Weaver Dairy Road Concept Plan (Aspen) Design Review

Drawings Dated 12/20/21

Plan Comments/Notes

Prepared by: Brian Peterson, AIA, Urban Designer, TOCH

Sketch 3

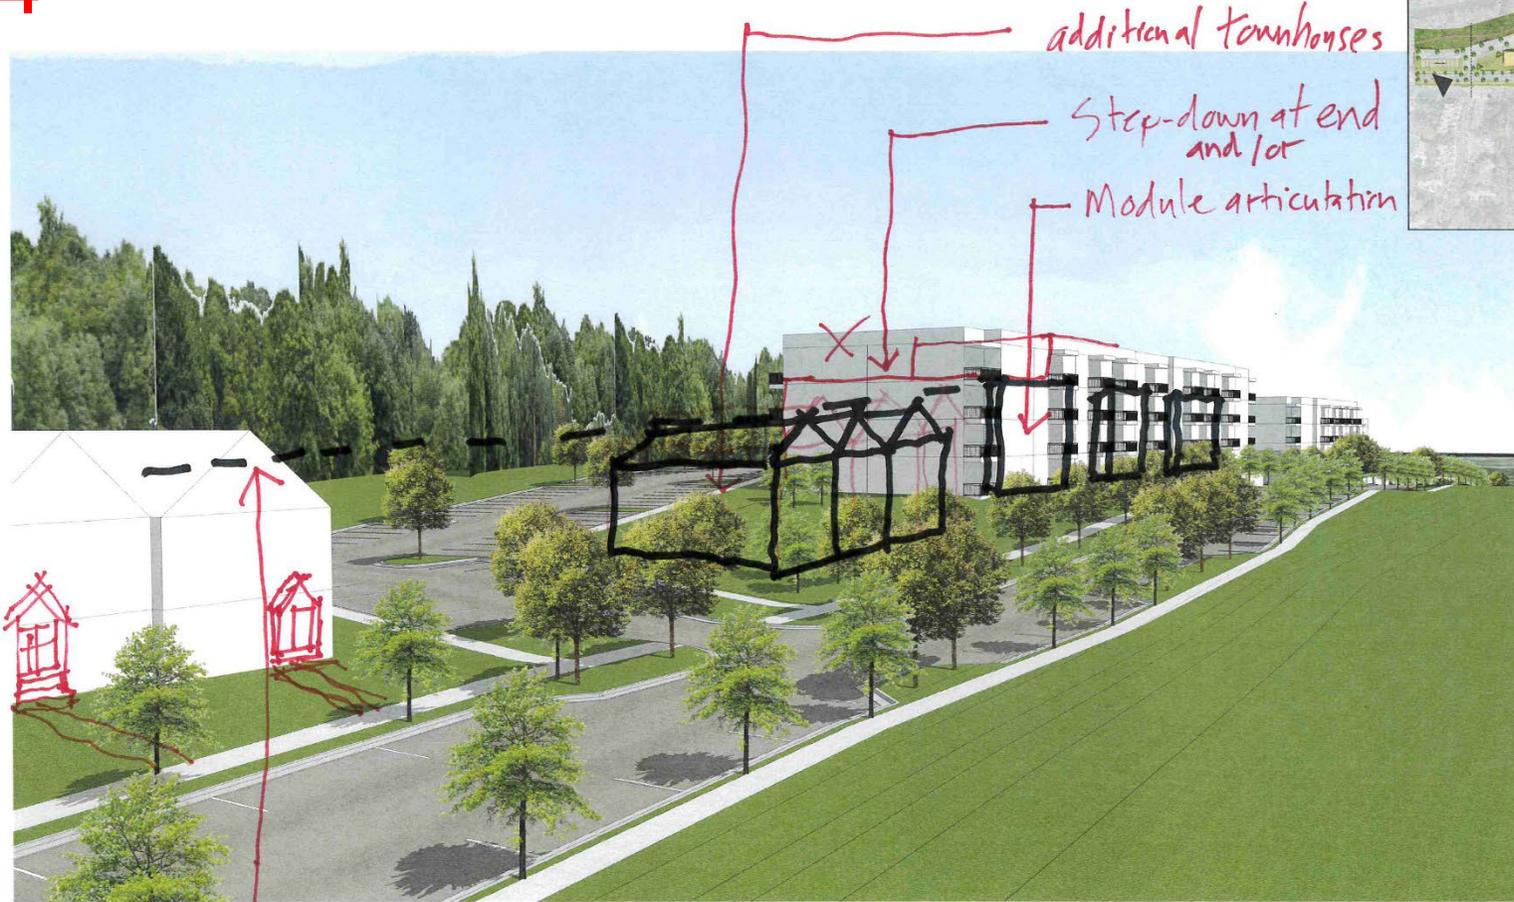
9. The multi-family building is very large: utilize architectural and massing strategies to help reduce the scale of the building such as breaking the singular building down into a series of several separate buildings, with corridor connections between buildings via exterior bridges spanning the gaps (sketch 3).
10. The apartment building mass will include some stepping down at various locations, to adjust to the sloping topographical conditions.

12. Verified that the townhouses along the site area connecting to Weaver Dairy Road will have their fronts facing east, along the street. Each unit will have a sidewalk and direct entrance from the street frontage (sketch 3). The units behind them will have their fronts facing west, accessed from a sidewalk that will extend along a linear green space. The townhouses will have their backs (with garages) facing the inner portion, in a “Garage Court” arrangement. Sidewalks should be provided in the gaps between the townhouse groupings so that visitors who are parking along the street can easily walk through the gaps to get to the entrances of the western-facing units.

"Fronts" of townhouses along street with sidewalks & front yards & street trees with planting strip between curb and sidewalk
